DESIGN REVIEW COMMISSION

February 5, 2020
MEETING AGENDA:

CITY OF JONESBORO, GEORGIA COUNCIL

Agenda Item Summary

Attachment: Site Pictures (1578 : Phoenix Tax Services Sign)

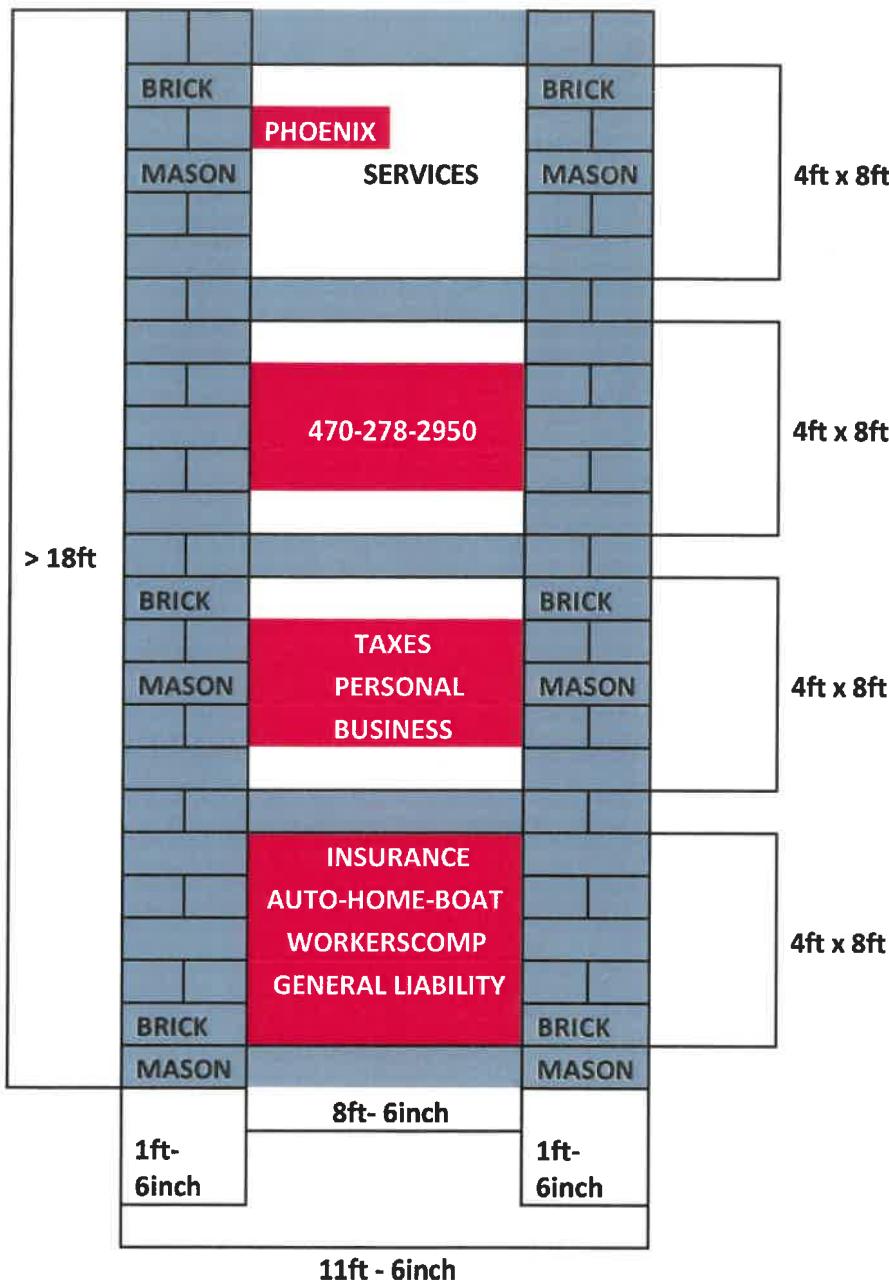
A few months ago, Mr. Sanchez of the recently established Phoenix Tax Services at 174 North Avenue informed the City of proposed modifications to the existing ground sign at the road. The sign is a “grandfathered” sign which has been standing at the front of the property for a long time. The initial proposal for the sign was just replacing the panels without addressing the metal frame, which has become worn and unattractive. After meeting with the City Manager and the Code Enforcement Officer, the applicant has proposed to wrap and conceal the metal posts and frame with brick and painting the brick (see enclosed). If approved, the sign would retain its current 18-foot height and 11.5-foot width. The location of the sign, which is closer than 10 feet to the right-of-way line would also not change. The sign would also have space for 4 panels, as opposed to the 3 it can accommodate now. The red and white color of the panels matches the Phoenix Tax Services established logo. The grey brick would match the color of the recently painted buildings on the property.

1. Allowing the applicant to do the proposed work as depicted, keeping the same height, width, and location as a “grandfathered” sign. Advantages: Less disturbance to the property and less expense to the applicant; Disadvantages: The spacing of the wording on the panels is very inefficient, more brick expense for the applicant. The sign would remain 3 times as tall as a new sign would be allowed in the same area. This would be more of a design for a planned center, and the property is not a planned center. May require a variance.

2. Tearing down the existing frame and constructing a whole new monument sign. Advantages: A fresher, more compact design. Disadvantages: More expense for the applicant and less visibility than what he has now. New design may jut into the front parking area. More disturbance.

3. Allowing the applicant to do the proposed work as depicted but cutting the sign height down to a point midway between the existing 18-foot height and the 6-foot height allowed and having less panel area. Advantages: Less disturbance to the property and less brick expense to the applicant. More efficient panels. Would allow greater visibility than a 6-foot tall sign. Have a recent precedent for this with the Citgo sign at 190 Jonesboro Road. Disadvantages: “Cutting” expense for sign height reduction. Not as much visibility as now. Would require a variance.

Technically, any significant alteration to the sign (even just wrapping with brick and adding more panels) would void the grandfathered status:

Therefore, even with the applicant's scenario, a variance would have to be sought for non-conforming height, total panel area, and distance from right-of-way. However, the applicant wants to take advantage of the greater sign height (more than 6 feet) that some of his adjacent neighbors still enjoy. Perhaps an effective compromise could be a similar scenario to the new Citgo sign at 190 Jonesboro Road, which was allowed a 12-foot height with an approved variance, thus making a more visually suitable sign while still acknowledging the need for a business to have good visibility.

(a) Ground signs, which are permanent, shall be permitted in non-residential zoning districts. No ground sign shall have a height greater than six feet above normal grade, or a sign face area greater than **35 square feet** (each side) for lots with a single building and 45 square feet (each side) for planned centers. No portion of a ground sign shall not be located within ten feet of a street right-of-way or within 50 feet of any other permanent sign, major structure or building. Changeable copy shall not exceed 33 percent of the area of the sign face. Ground signs are allowed only on lots upon which there is a building which is currently occupied pursuant to a current and valid certificate of occupancy issued by the city or which is currently being developed under an active building permit issued by the city. **Proposed design would have 256 total square feet of panel area (two-sided).**

Staff Recommendation (Type Name, Title, Agency and Phone)**Denial of Applicant Design**

C MS-3A DOUBLE FACED INTERNALLY ILLUMINATED MONUMENT SIGN | ONE (1) REQ.
scale 1/4"=1'-0"

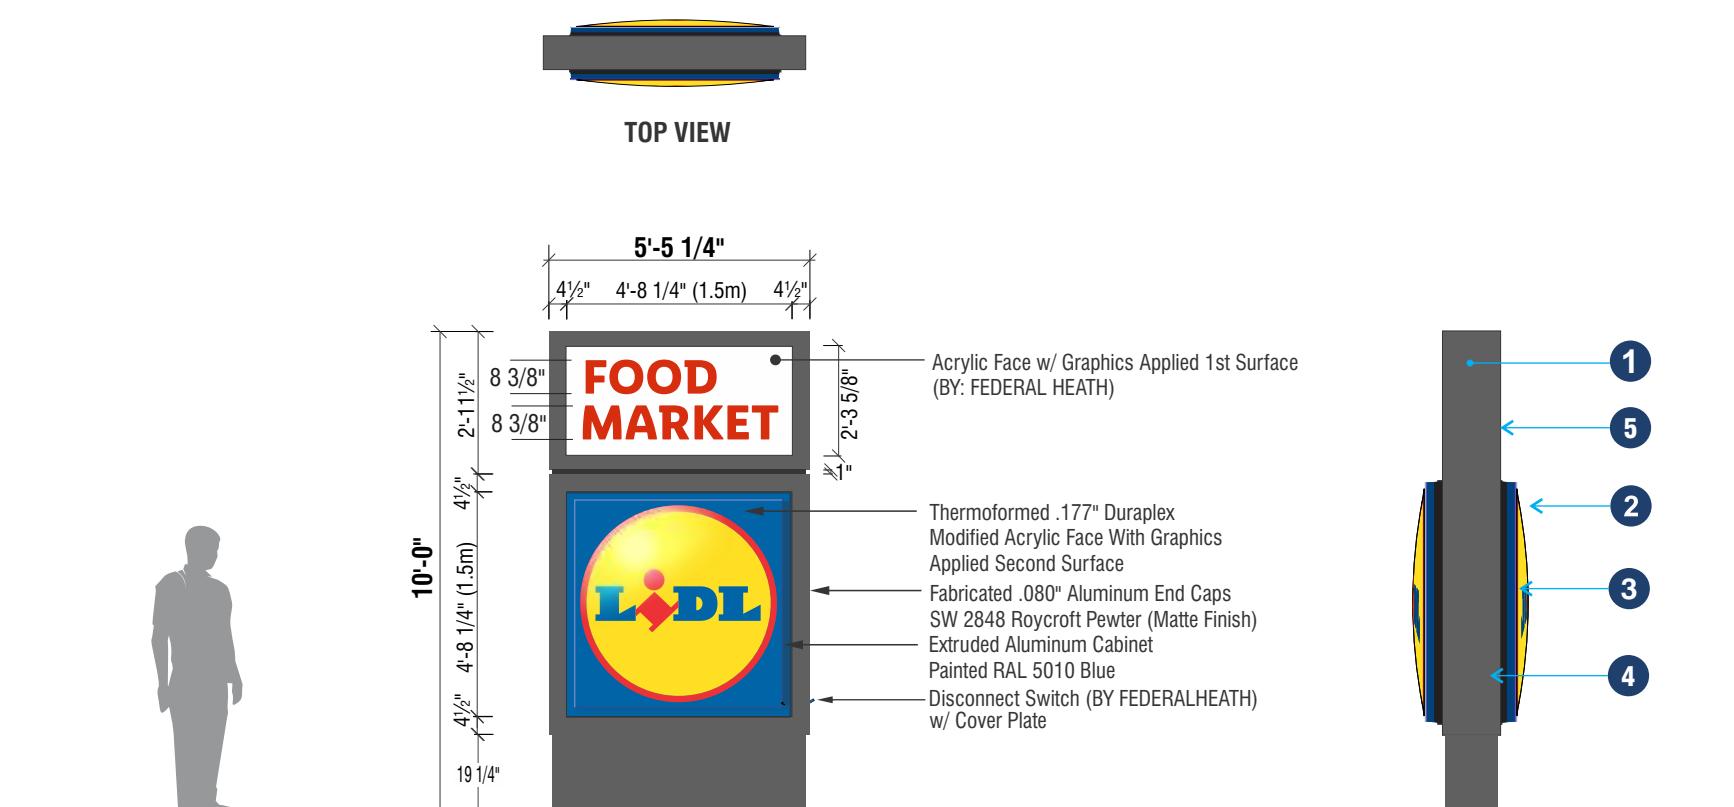
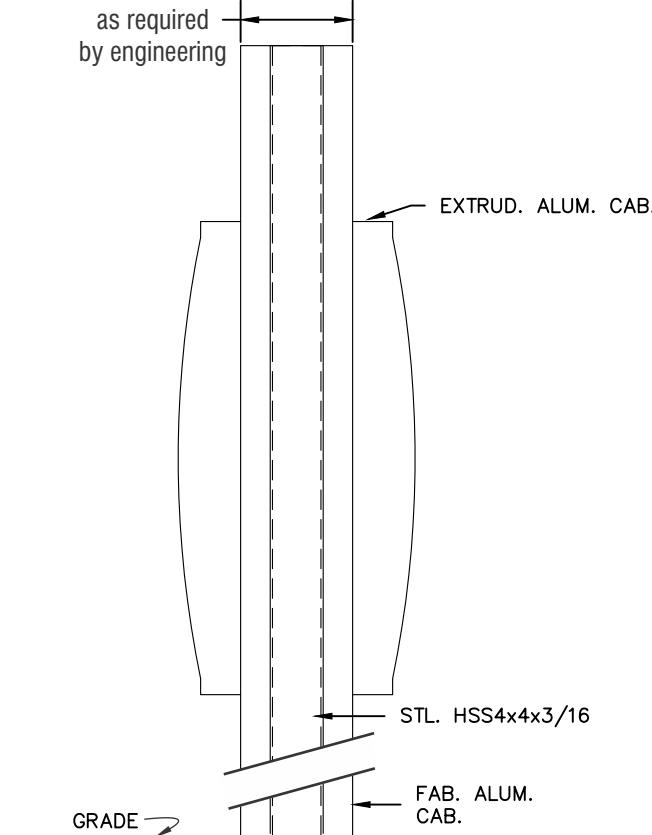
Before you are the designs for the previously approved wall signs (slightly smaller than before) and two new ground signs. Staff already did a preliminary analysis of these signs for LIDL:	
As stated before, all of the sign designs (monument and wall signs) will need to be reviewed by the Design Review Commission on February 5th.	
Wall Signs (One on the east side and two on the north side of the building) <ul style="list-style-type: none"> - There are 3 wall signs proposed (logos plus words), for a total of 195 square feet. Normally, only two wall signs would be allowed for this multiple frontage property at a maximum total square footage of 150 square feet. However, a variance for this situation (number of signs and square footage) was already approved in May of last year. - Therefore, beyond Design Review and paying for the permit, no additional zoning requirements are needed. 	
Monument (Ground) Signs (One fronting Tara Blvd. and a new panel on an existing frame on North Avenue)

A lot with one building facing a primary arterial, which building is currently occupied pursuant to a current and valid certificate of occupancy issued by the city, shall be permitted one double-sided ground sign to be located within a minimum of 10 feet from but a maximum of 100 feet from the right-of-way of the primary arterial, each side of which shall not exceed 150 square feet signage face area. The height of the sign shall not exceed 20 feet. **The proposed Tara Blvd. sign is allowed more height and area than the North Avenue sign. It meets these requirements and is 10 feet off of the right-of-way. The sign panel on the existing monument sign along North Avenue (below CVS panel) would be grandfathered in terms of location. The North Avenue sign would only be charged for the new LIDL panel, which is 25 square feet on one side, below the 32 square foot maximum.**

In view of the variance approval last year, the fact that all proposed signs meet Code criteria, and the colors of the signs are typical for LIDL and will not be inappropriate for the surrounding area, staff is recommending approval of the wall signs and ground signs.

Approval

Variance request #8 – *Paved or striped islands greater than 50 square feet shall not be allowed. Sec. 86-458 (10)*

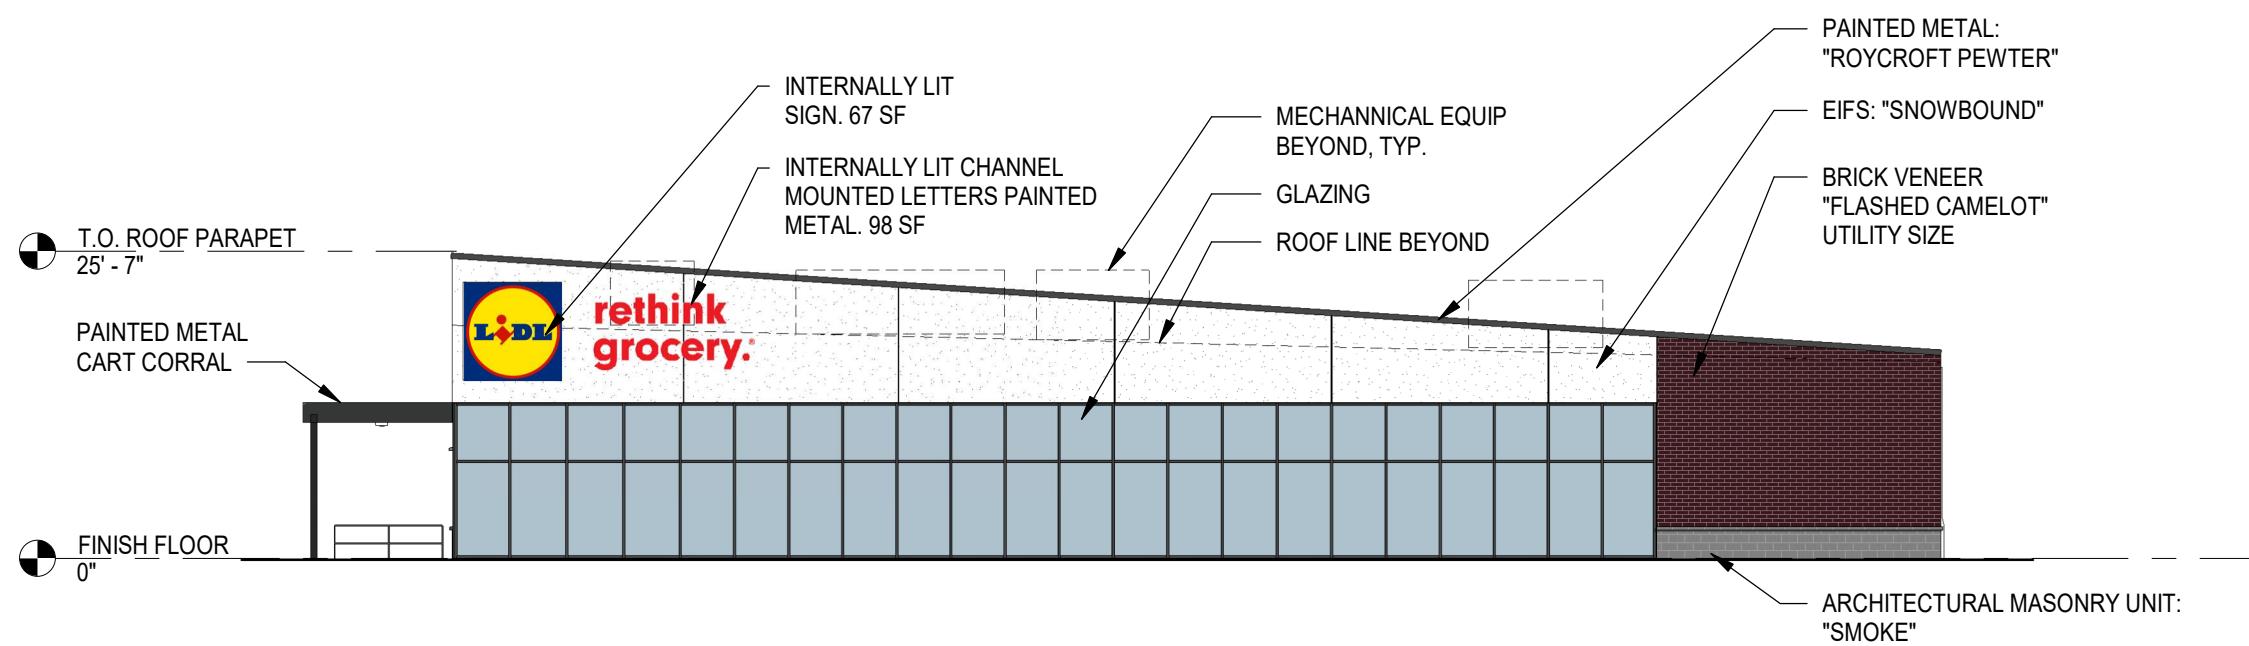
This area near the southern portion of the site is large enough to allow large trucks greater ease in circulation and parking before and after loading. It will not be very visible from Tara Boulevard.

B Cabinet Reface (2) Required

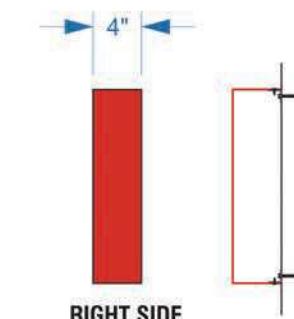
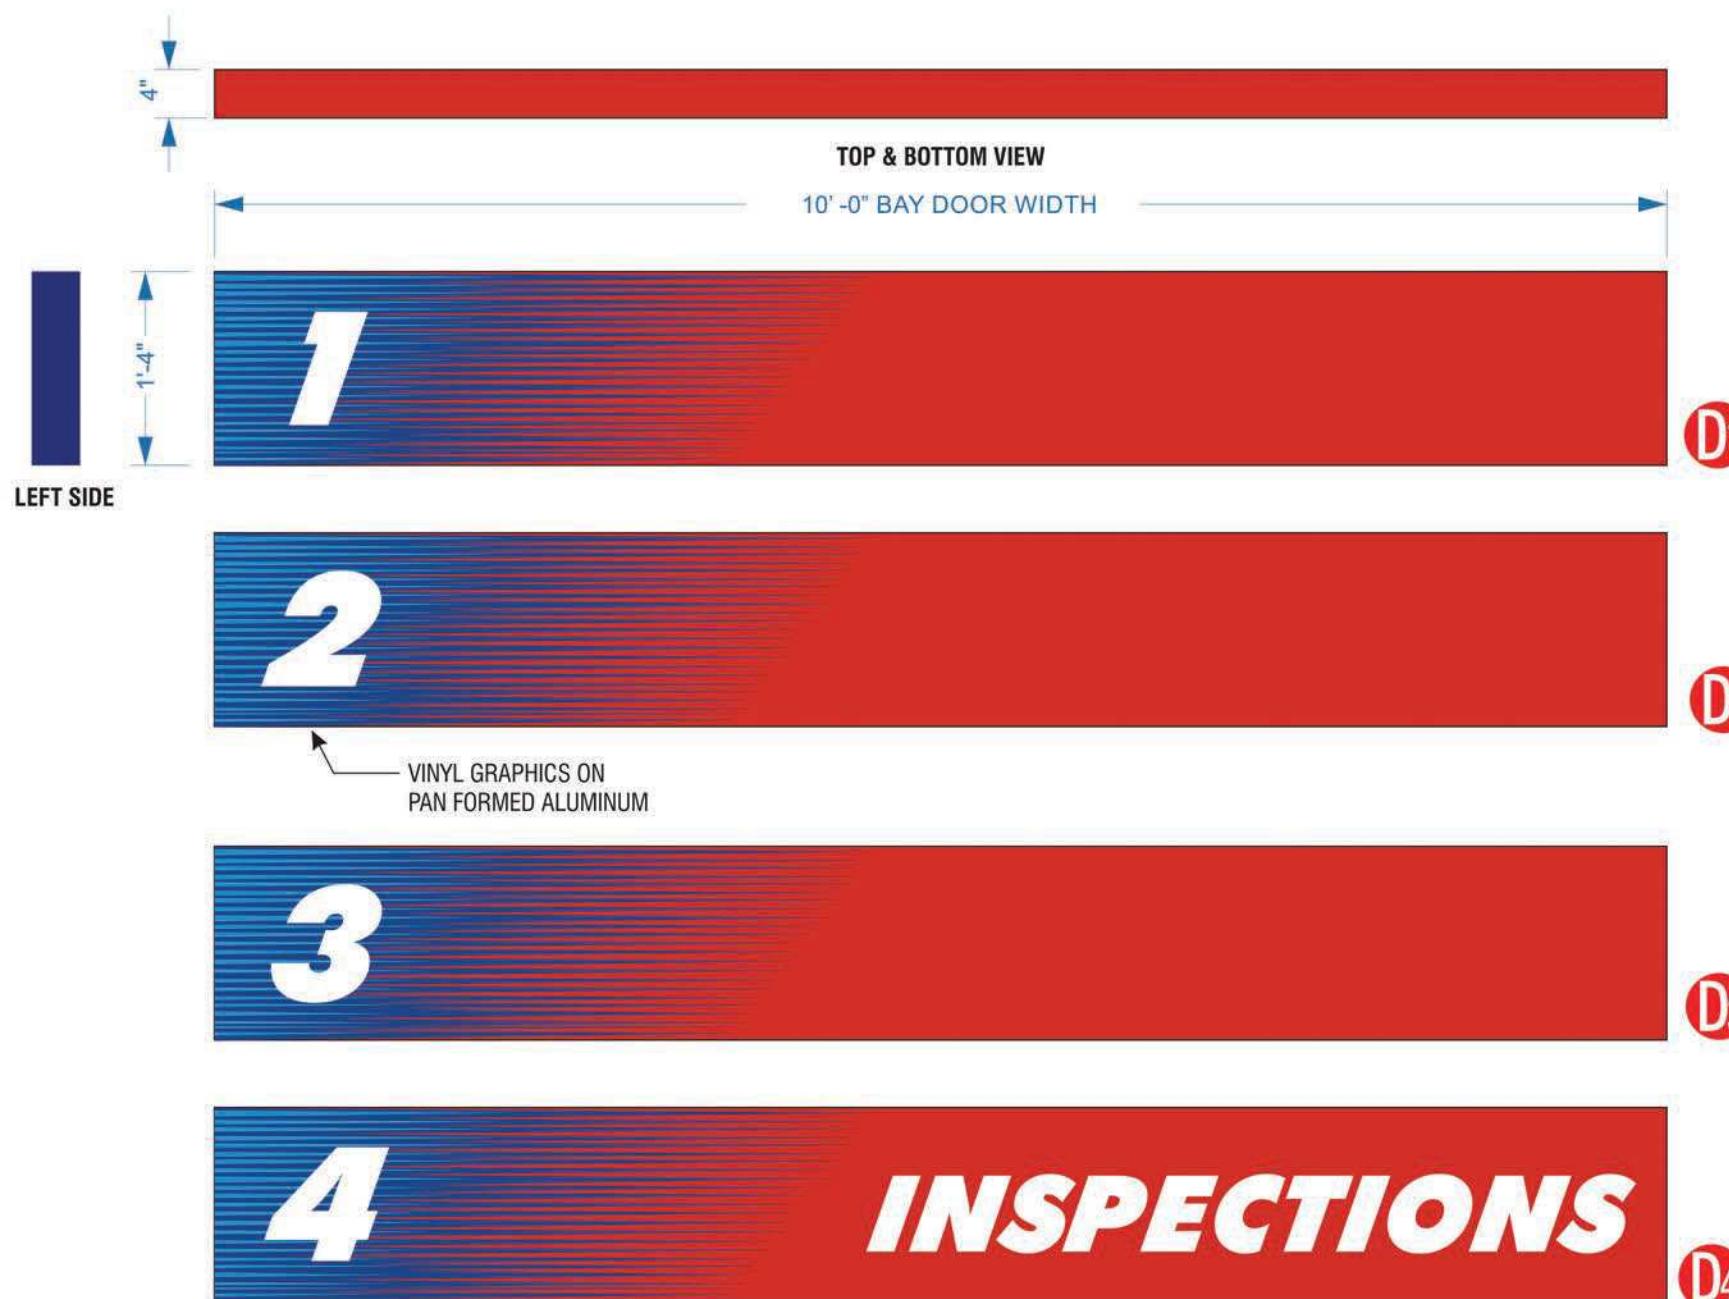
The Express Auto Care panel (below the Window Tinting panel) is being replaced by a Valvoline panel within an existing framework. There will be no change to the size or location of the framework. The new panel (double-sided) will be the same size as the previous panel – 50 square feet.
